**RESPONSE TO MINISTERIAL  
INFORMATION REQUEST NO. 8**

Addendum to the Touquoy Gold Project  
Modifications – Environmental  
Assessment Registration

March 2022  
Co-branded

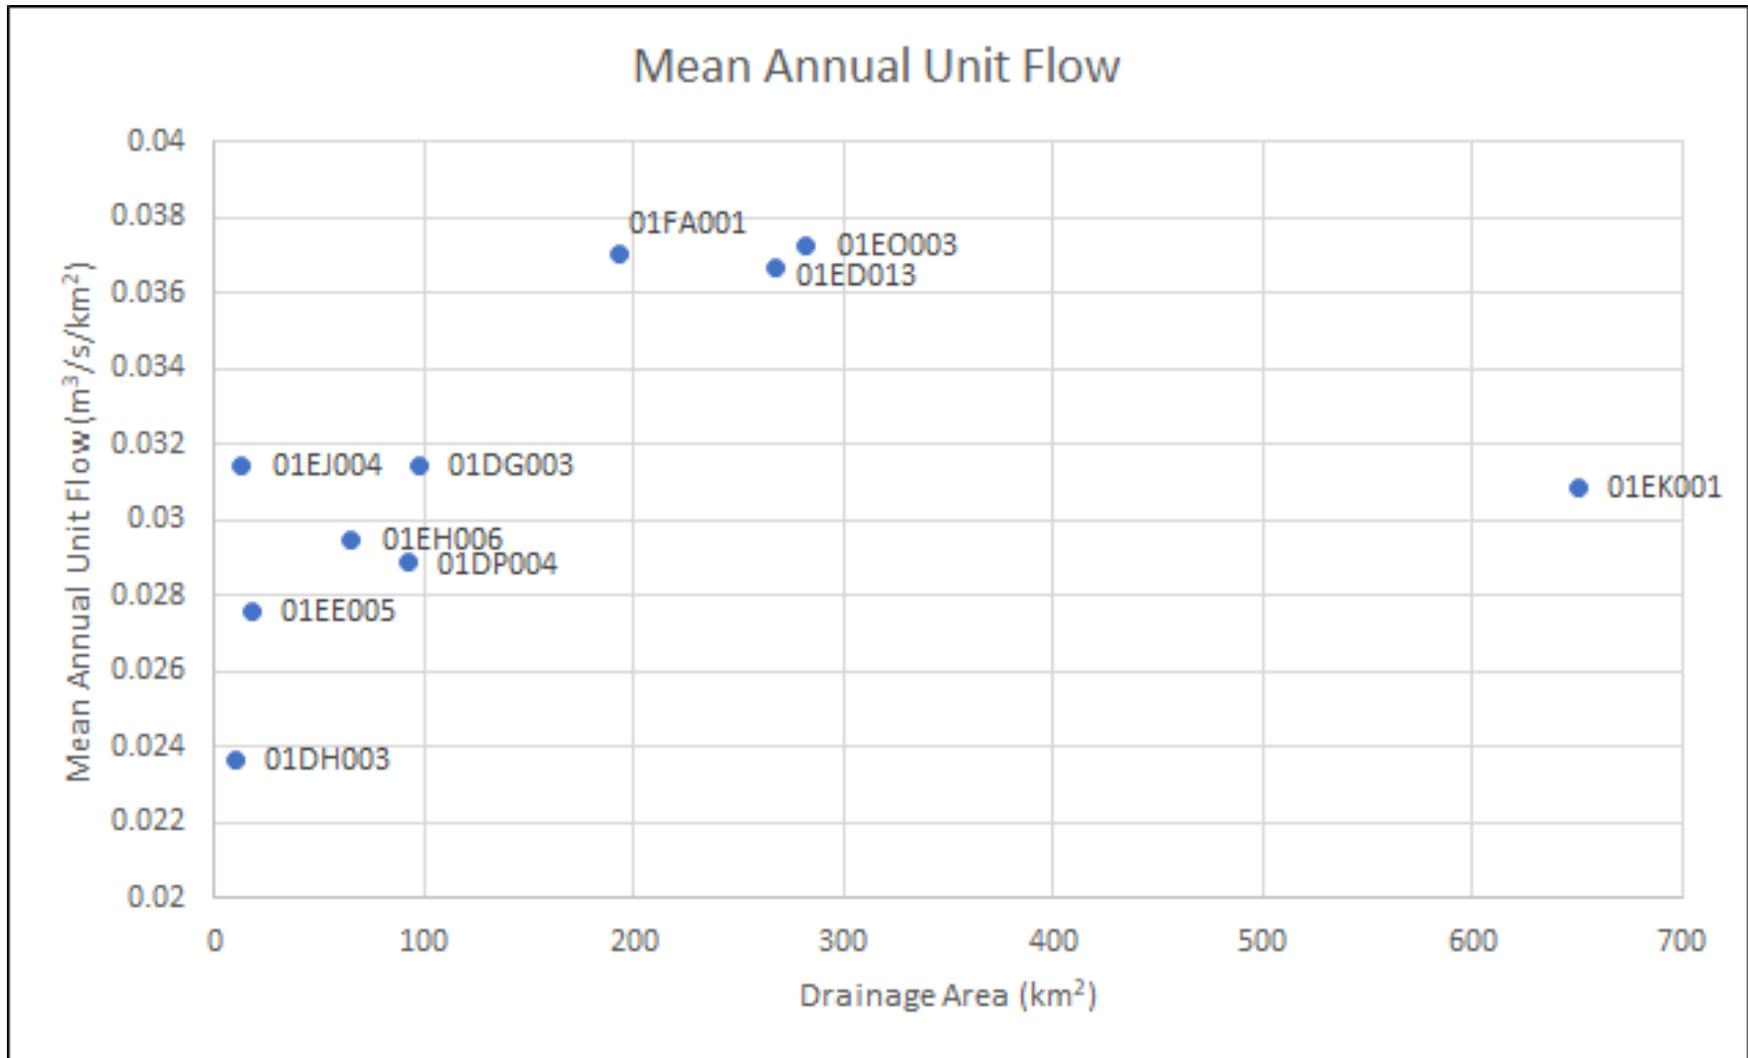
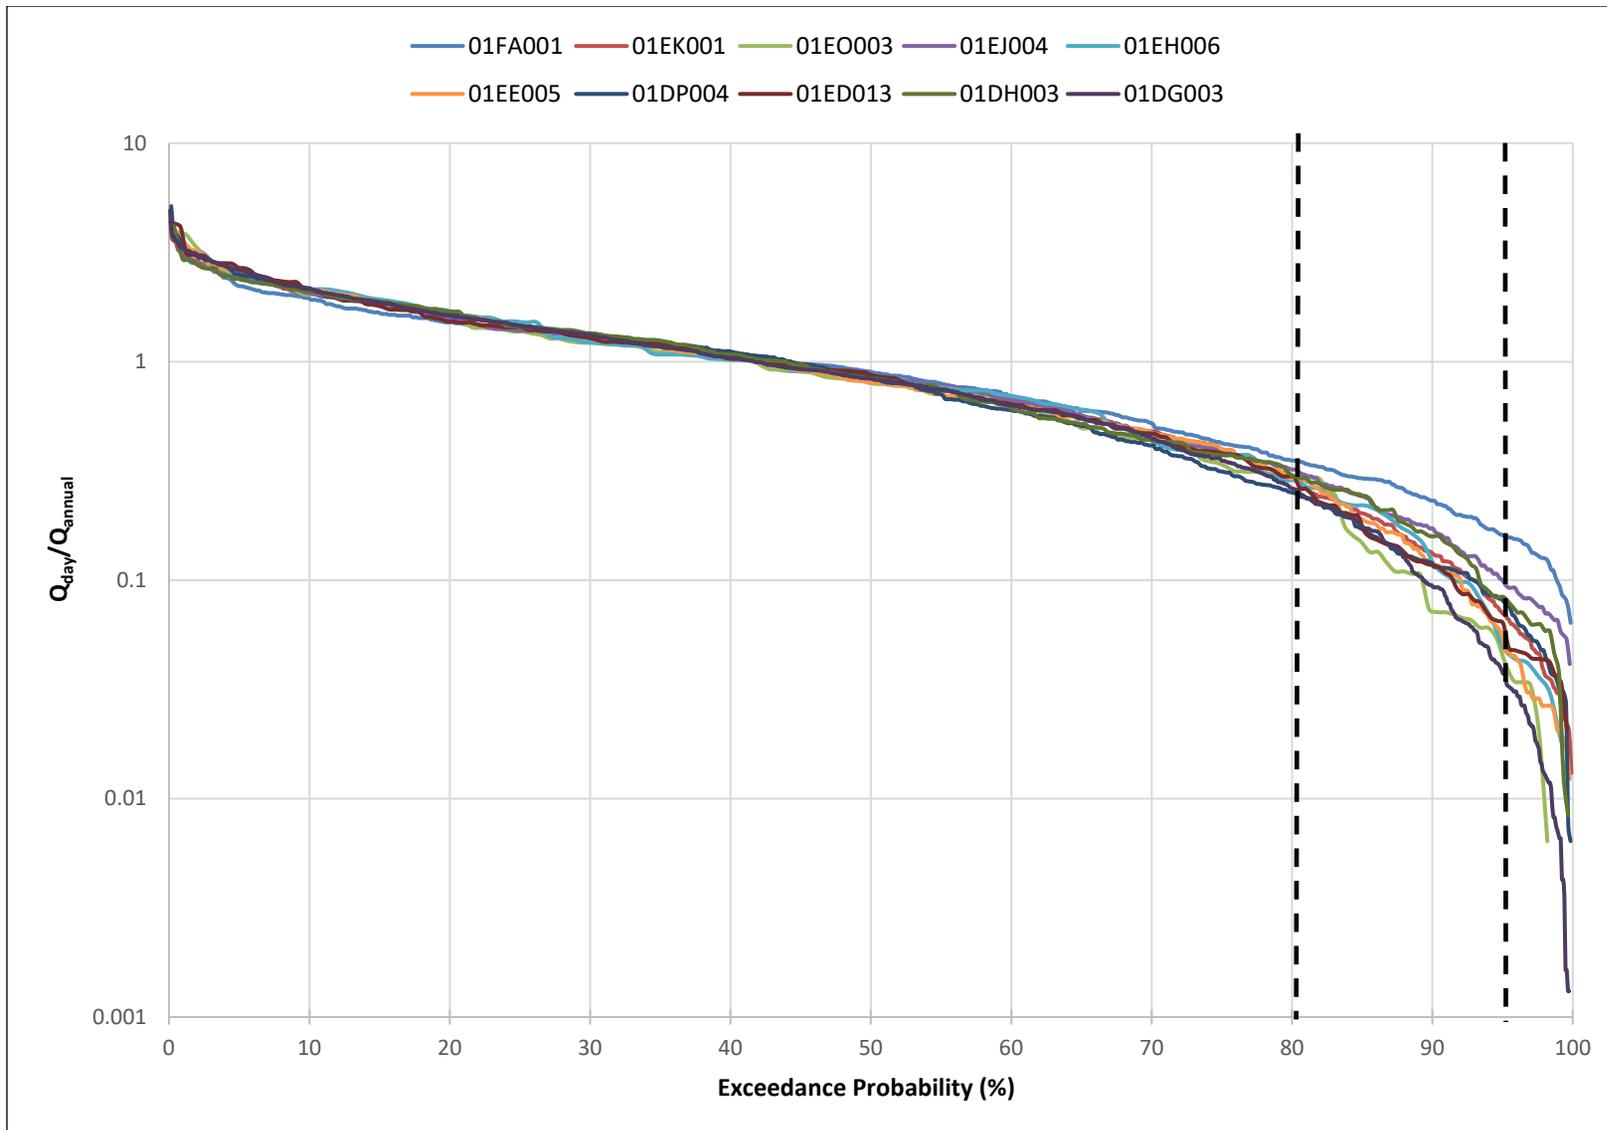
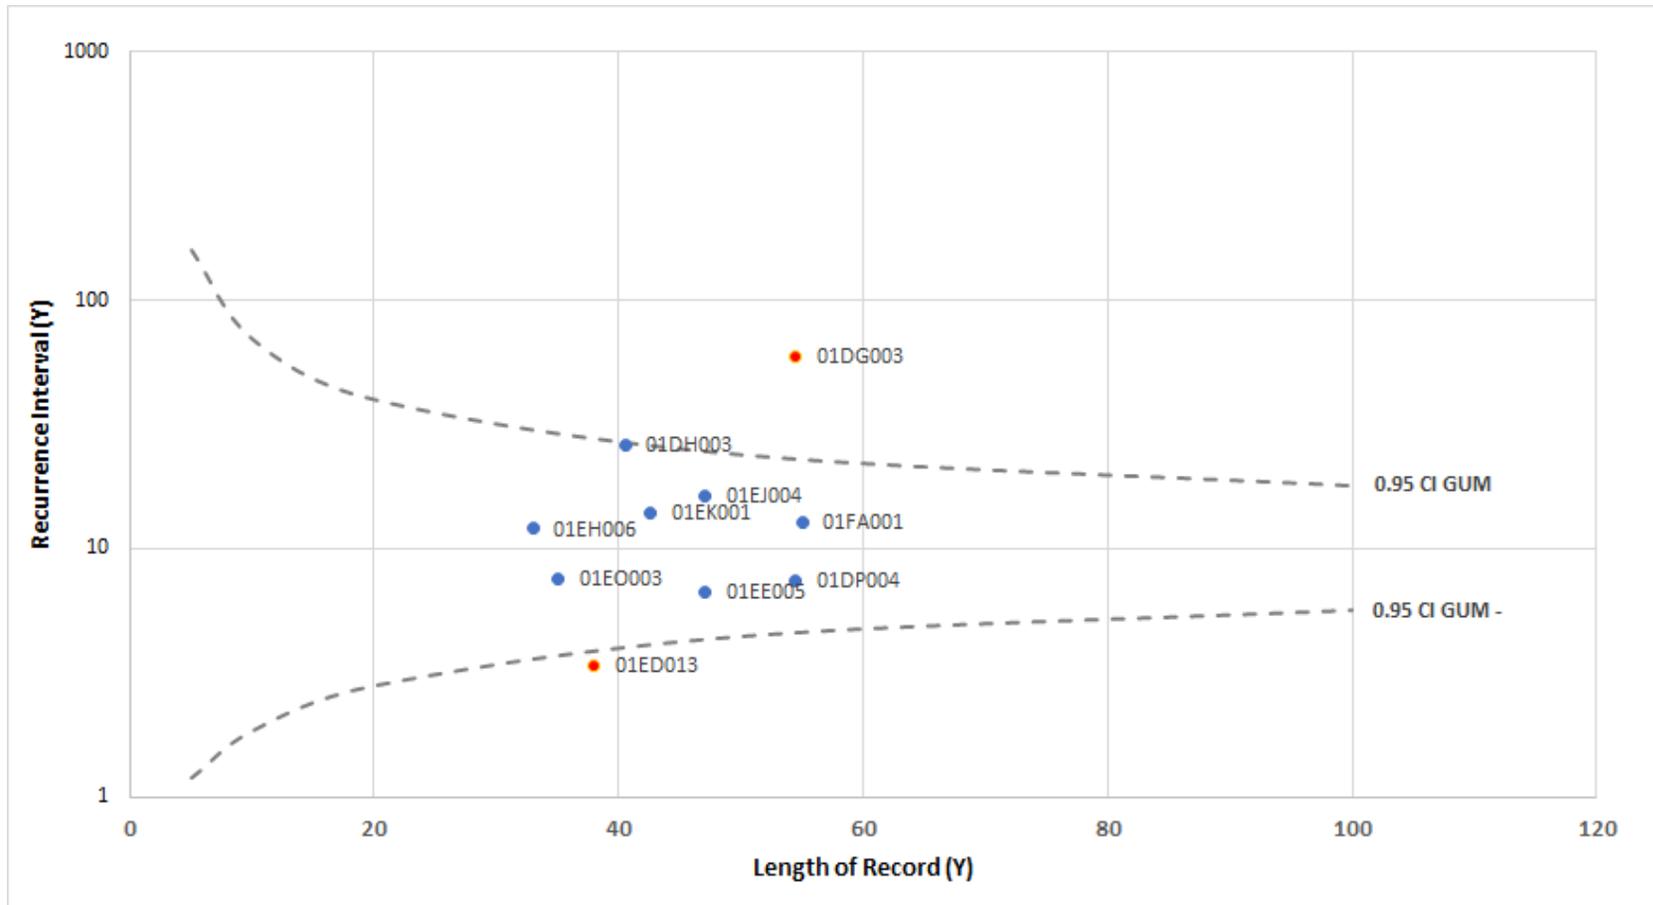
*What validation of these estimations has taken place?*

- Unit Flow – Unit flows are presented in Figure 2.1 below and range from 23.69 – 37.23 L/s/km<sup>2</sup> with 01EJ004 and 01EK001 presenting outside the linear trend of increasing hydraulic efficiency with increasing drainage area.

- Flow Duration Curve (FDC)- The FDCs for the regional dataset are presented below in Figure 2.2. All station FDCs follow a similar shape pattern with little FDC cross-over indicative of FDC variance.

- Index Flood Flow - In the flood indexing approach, the 95<sup>th</sup> confidence interval has been used to assess the homogeneity of the regional dataset using the Mean Annual Flood (recurrence interval of 2.33 years) as the Index Flood, the 10-year flood, and their ratios. The Index Flood test results are presented in Figure 2.3. The two stations (01DG003 and 01ED013) with the lowest homogeneity of flood flow relative to the regional dataset are shown in red on Figure 2.3. Station 01ED013 plots near the 95th percentile threshold of the Gumbel Distribution test; however, 01DG003 (Beaverbank near Kinsac) plots well outside the 95th confidence interval for the Gumbel Distribution test

**Figure 4.1 2021 SW-19 Hydrograph and Estimated Hydrographs with and without Flow Supplementation from the New WRSA Sedimentation Pond**

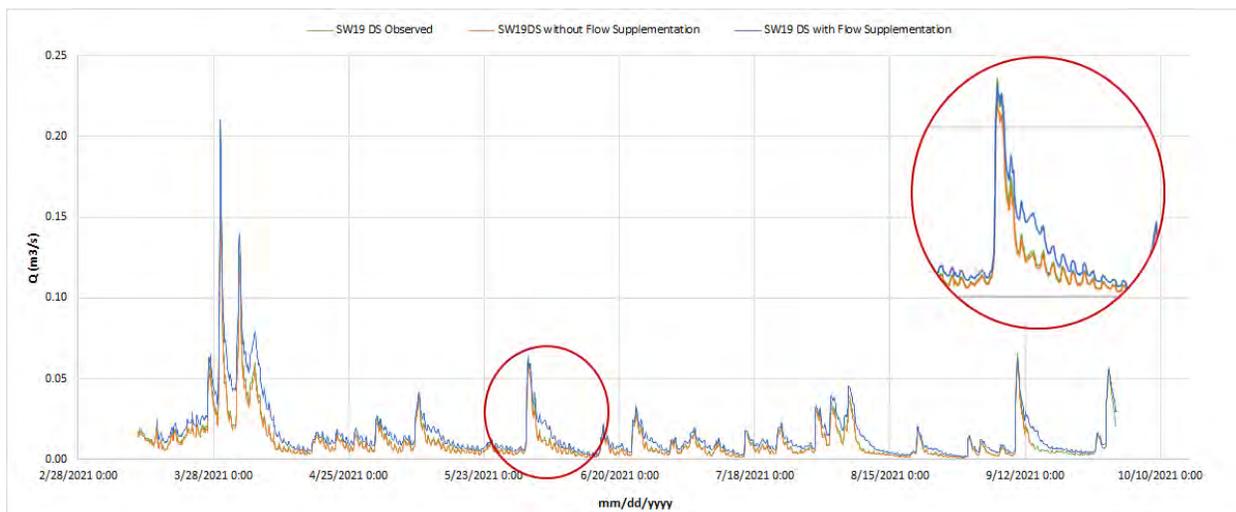
*Context: The report goes on to say that “Returning flow from a 20.5 ha section of the WRSA drainage area would return approximately 12,198 m<sup>3</sup> to the watercourse on an annual basis, thus achieving no net change in surface water quantity to Watercourse #4.” (pg. 7.33). The previous page had outlined that this approach would “make up the anticipated instantaneous to annual flow volume loss...”, but discussion related to the impacts of the proposed settling pond/treatment approach on instantaneous flows is not provided*

Notwithstanding that detailed design of the WRSA new sedimentation pond and the associated hydrologic and hydraulic modeling has not occurred, nor the stated objectives of instantaneous flow hydrograph matching, the following presents an empirically based estimate of anticipated instantaneous flow changes in Watercourse #4 at the new sedimentation pond FDP.

Local flow station SW-19 was established on Watercourse #4 upstream of Mooseland Road in sub-catchment 1. The hydrograph for the 2021 flow monitoring period at SW-19 is presented in Figure 1.5.j-1. The upstream catchment area of SW-19 is 61.3 ha. The WRSA expansion includes 5.1 ha of the existing Watercourse #4 drainage area and represents 8% of the SW-19 upstream catchment. Therefore, without flow supplementation, the SW-19 hydrograph would be reduced as indicated in Figure 1.5.j-1. To estimate and present the anticipated effect of the WRSA expansion new sedimentation pond on flows at SW-19 a short distance downstream from the proposed new FDP, hydrograph separation was conducted. The residual unaffected upstream catchment of SW-19 would produce flows as per the “without flow supplementation” hydrograph. To estimate runoff and seepage to the WRSA new sedimentation pond and then to the FDP, hydrograph simulation was conducted based on a total proposed WRSA contributing area of 20.4 ha and then the hydrograph was reduced to account for the reduction in runoff coefficient observed between natural ground (0.67) and the existing WRSA (0.43). Subsequently, to account for runoff and seepage lag and detention time in the pond the WRSA 20.4 ha contributing hydrograph was adjusted using a moving average which attenuates peaks and extends its baseflows. The results of the estimated resulting flows at SW-19 are presented in Figure 1.5. j-1 and will be confirmed by the modeling proposed in 1.3.e.
